STAFF RECOMMENDATION
2108 11th Avenue South
November 19, 2018

Application: New Construction – Addition
District: Waverly-Belmont Neighborhood Conservation Zoning Overlay
Council District: 07
Map and Parcel Number: 10513017000
Applicant: Mitch Hodge
Project Lead: Melissa Baldock, melissa.baldock@nashville.gov

Recommendation Summary: Staff recommends disapproval of the addition, finding that its scale and roof form do not meet Sections III.B. and IV.B. of the design guidelines.

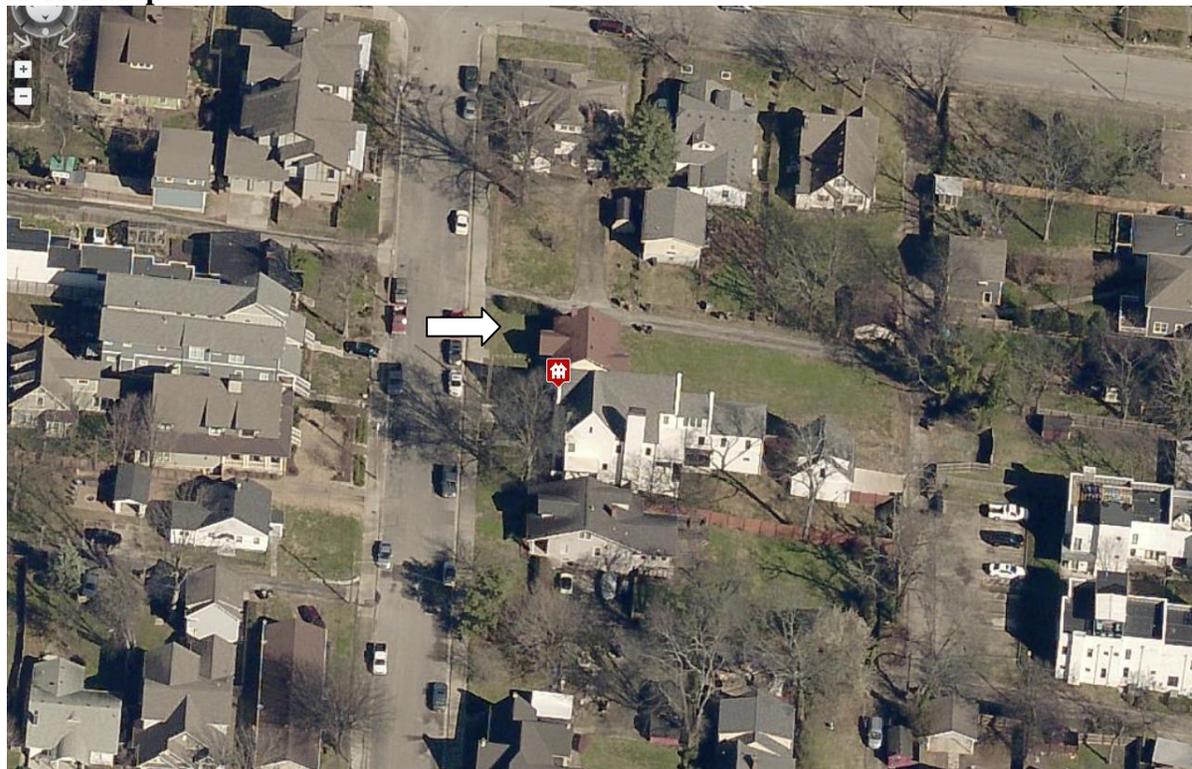
Description of Project: Application is to construct a rear addition. The addition has a footprint that is over three times the size of the historic house’s footprint. The rear addition will add a second residential unit to the lot, which is allowed under the base zoning.

Figure 6 shows the relative size and scale of the existing roof form with the size and scale of the proposed addition's roof.

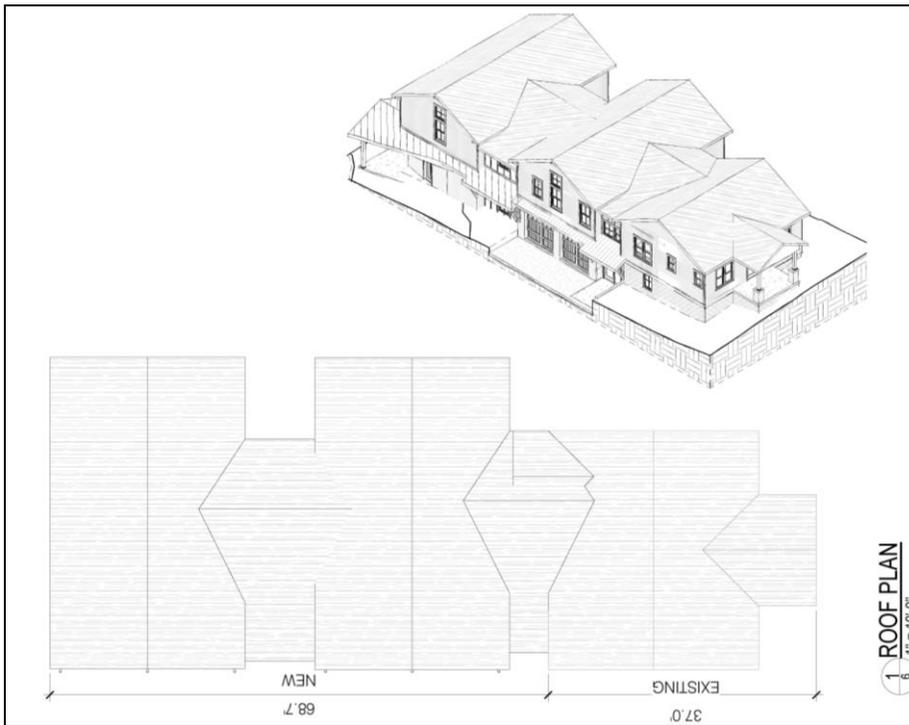
Roof form: The propose roof form for the addition is a series of gables with a 6/12 pitch. This is similar to the house's roof form and pitch. However, staff finds that the multiple roof forms tied together to create a long addition are not compatible with the simple side gable of the historic house (Figure 6). The size of the addition results in a roof form that is not compatible with the historic house's roof form because it is too large and too complicated by comparison.

Staff finds that the proposed roof form does not meet Sections III.E. and IV. of the design guidelines.
